Technical Bulletin 212

02.2021

Description: Triumph Diagnostic Tool (TDT) - Enable Connectivity System Process Update

Item:	212.4
Description:	Electronic Systems Commissioning and Motorcycle Unlocking
Model Affected:	Tiger 850 Sport, Tiger 900, Tiger 900 GT, Tiger 900 GT-LRH, Tiger 900 GT Pro, Tiger 900 Rally, Tiger 900 Rally Pro

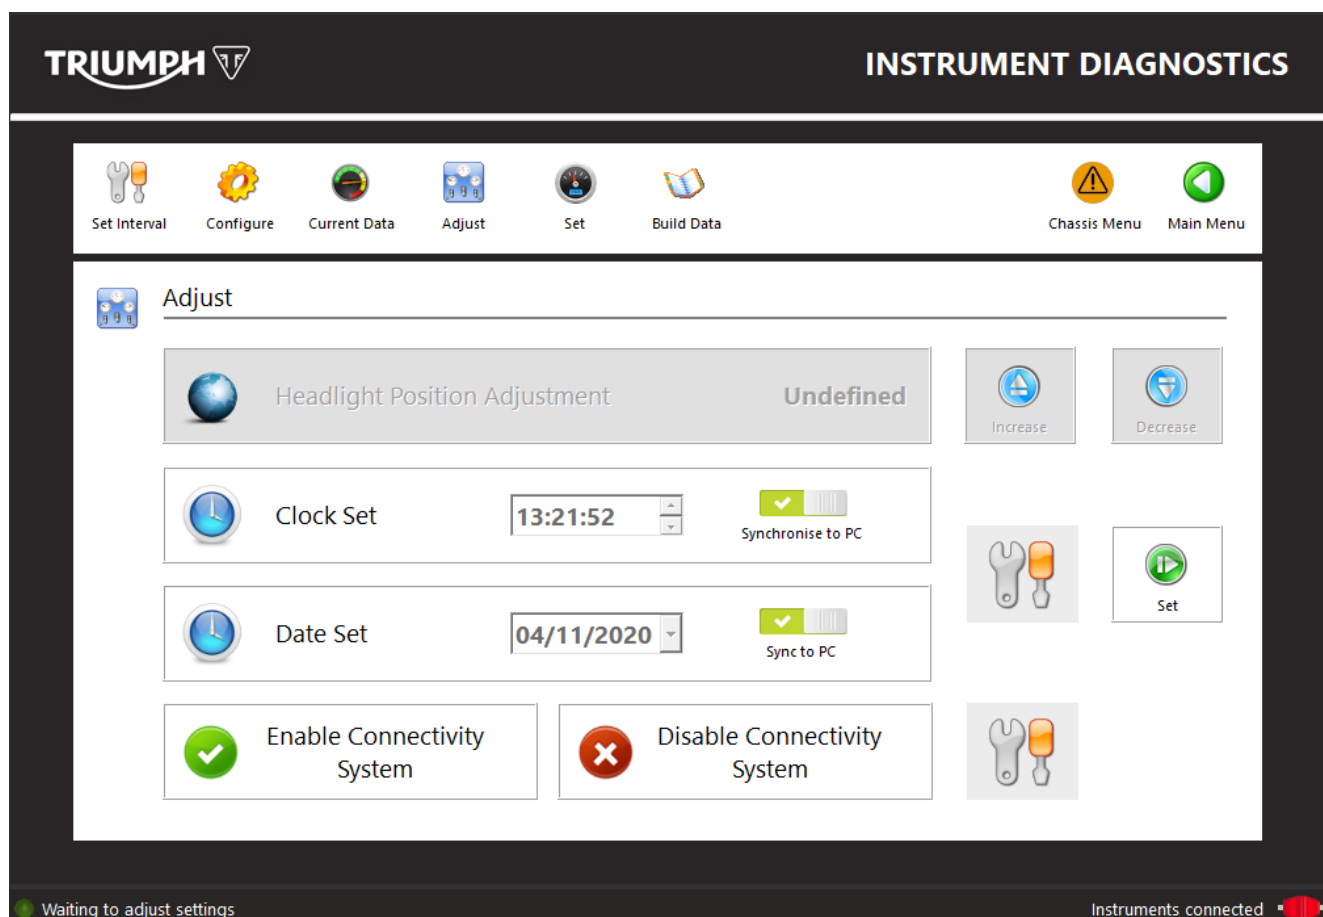
The process for performing the calibration updates and actions necessary to enable the accessory My Triumph Connectivity Module has changed in the Triumph Diagnostic Tool (TDT).

The TDT 2020-12 update includes a new 'Enable Connectivity System' wizard. The new wizard will perform all calibration checks, downloads and actions necessary to enable the system.

The instrument VIN check/update feature has now been removed from the Instrument download process for TFT instruments. This feature is now included in the Enable Connectivity System wizard described above.

Enable the Connectivity System (Tiger 900 GT Pro and Tiger 900 Rally Pro models only)

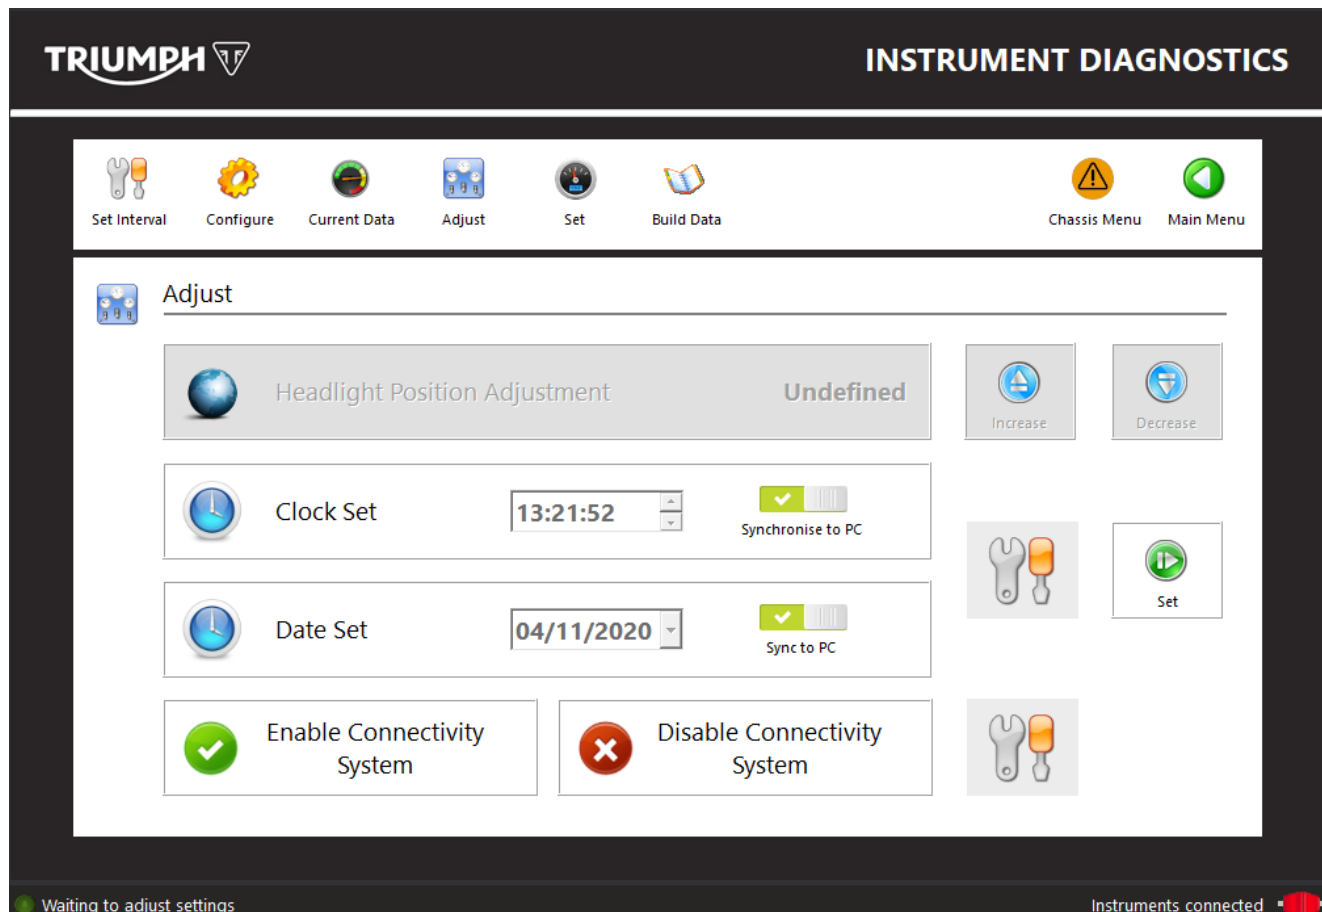
This revised item replaces Technical Bulletin 209 item 5 (TB 209.5) dated August 2020. Changes to this revised item are as follows:

- **Tiger 850 Sport added to list of applicable models.**
- **Instrument VIN check/writing feature has been removed from the instrument calibration download. This feature is now performed as part of the Enable Connectivity System process.**

- The Connectivity Module is fitted as standard on Tiger 900 GT Pro and Tiger 900 Rally Pro models. The Connectivity Module is available as an accessory for other models in the Tiger 900 range. The accessory fitting instructions should be followed if installing an accessory Connectivity Module.
1. Navigate to CHASSIS DIAGNOSTICS - INSTRUMENT DIAGNOSTICS - Adjust.
 2. Click Enable Connectivity System.
 3. Follow all onscreen instructions.
